# Building Code of Australia 2016

Report for BCA Compliance

PROJECT NAME: Sydney Opera House – Renewal Project – Front of House – DA2a Submission  
Ballet Rehearsal Room & Function Centre

DATE: 21 September 2016

Figure 2 – BRR FRL Plan

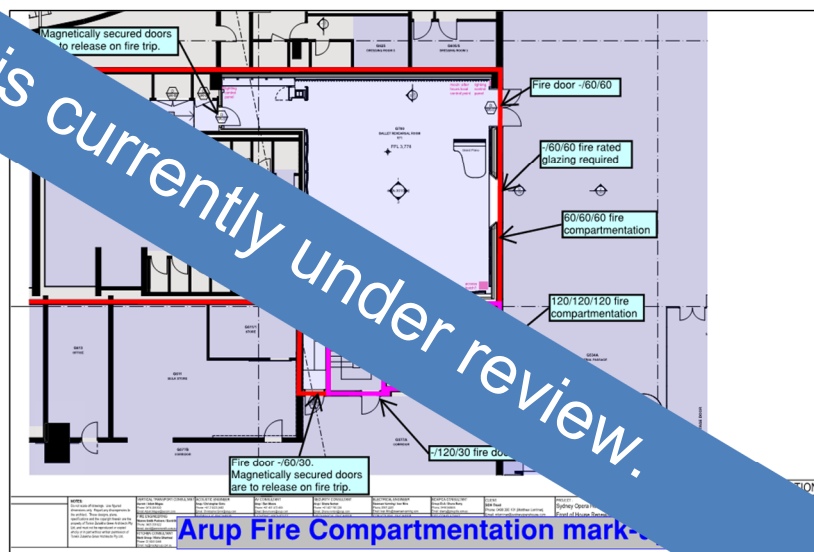
It is noted that the Fire Safety Engineer has provided an FRL Compartment plan for the BRR. Walls are illustrated at 120/120/120 rather than 120/120/120 which will require a Performance Solution if the 60 minute FRL is not supported by the relevant existing site FER. The plans also require the window and doors to contain a 60 minute FRL, see Figure 2:

The current plans illustrate the BRR window as “switchable” this may not be feasible as the window must contain an FRL of -60/60 and be fixed permanently in position. Additionally the noted timber window may not be feasible for a fire window. There may or may not be limitations on the close proximity of timber lining windows which would be an issue for the Wobbly lining. Further discussion on these points is required.

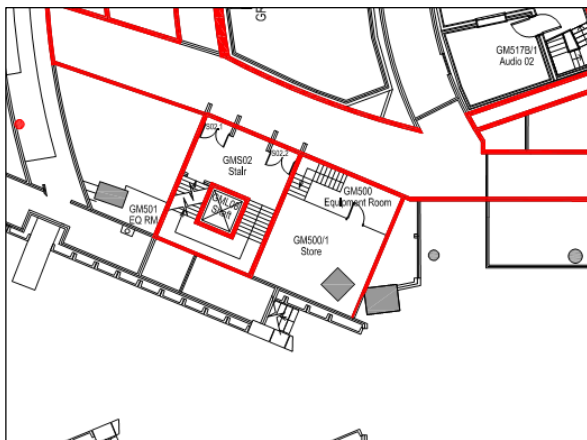
An overall egress strategy is to be developed by the Fire Safety Engineer and is understood to consider items such as:

- The reconfiguration of the fire exit stairs. Including the effect on the stair widths
- Internal stair discharge issues at stairs adjacent GL03 & GL08, rather than direct to the outside, (FC).
- Possible undersized egress widths. (ALL)

- Possible extend travel distances from the proposed Ballet Rehearsal Room and surrounding areas, due to the deletion of the fire exit door into fire stair GRS111, TBC. (BRR)

Figure 3 – Fire Stair 2 Changes

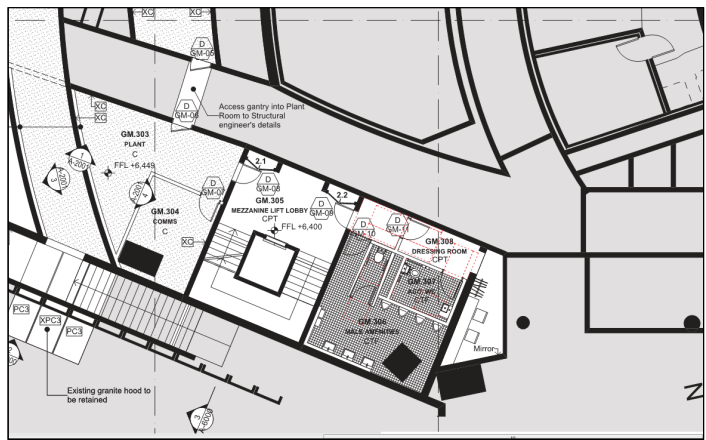
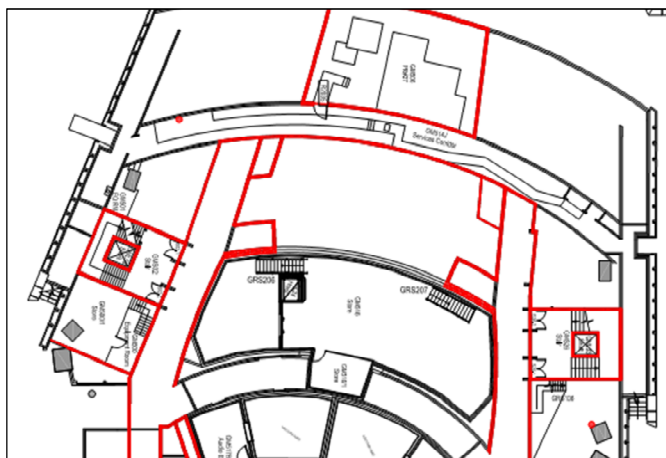
FC – Proposed alterations to Mezzanine Level Stair 2 / Lift 8 lobby see the requirement for an upgrade consideration to the Stair 2 and Lift 8, for compliance with BCA 2016, see Figure 3 below illustrating the changes as Mezz. It is noted that the JST project also contains significant changes to Stair 2 at Level 2 & 3 and as such the relevant BCA Report dated 5 August 2016 also notes a requirement for an upgrade to be considered. Furthermore, the DA2 BCA Report dated 5 August 2016 also requires with Stair 26 & Lift 3 for the Eastern Accommodation Project documentation. Fire Safety Engineer to review and confirm the feasibility of any justifiable Performance Solutions. See Table 6 below for the relevant BCA issues to be considered.

Item #	Item	Requirement Summary	BCA Clause and Performance Requirements
1	Fire Ratings	<p>Lift shaft and stair shaft to achieve a Fire rating of not less than 120/120/120.</p> <p>Additionally the stairway is required to be constructed of non-combustible materials, and so that if there is a local failure it will not cause structural damage to, or impair the fire resistance of, the shaft.</p> <p>Structural Engineer to confirm. Any shortfalls can be referred to the Fire Safety Engineer to confirm the feasibility of a Performance Solution.</p>	C1.1, C2.10, D2.2, CP1, CP2, DP5.
2	Separation of the Lift shaft and fire stairs.	<p>Does not comply as the lift and stair are located within the same shaft.</p> <p>Fire Safety Engineer to confirm the feasibility of a Performance Solution.</p>	C2.11, CP2, DP5.

Item #	Item	Requirement Summary	BCA Clause and Performance Requirements
3	Fire Doors	<p>Fire stairs entry doors are required to contain an FRL of no less than -/60/30 and the lift doors no less than -/60/-.</p> <p>Existing ratings to be confirmed. An audit of these doors may have been completed as part of the current FRL plan updated project? Any shortfalls can be referred to the Fire Safety Engineer to confirm the feasibility of a Performance Solution.</p>	C3.8, C3.10, CP2.
4	Services Penetrations. Cupboards or the like.	<p>The BCA limits the amount of penetrations that are permitted within a fire isolated stair to electrical wiring associated with serving the actual fire exit stair, pressurisation ducting for the actual fire exit stair and water supply pipes for fire services.</p> <p>Additionally, these required services must be adequately fire sealed, along with any control joints in the structure.</p> <p>Cupboards and access to services within the fire isolated stair is not permitted.</p> <p>An audit of the fire stair is required to be conducted to determine compliance. Any shortfalls can be referred to the Fire Safety Engineer to confirm the feasibility of a Performance Solution.</p> <p>It is noted that Level 2 contains non-compliant cupboards to be replaced, that are to be considered by the Fire Safety Engineer.</p>	C3.9, C3.15, C3.16, D2.7(e), CP8.
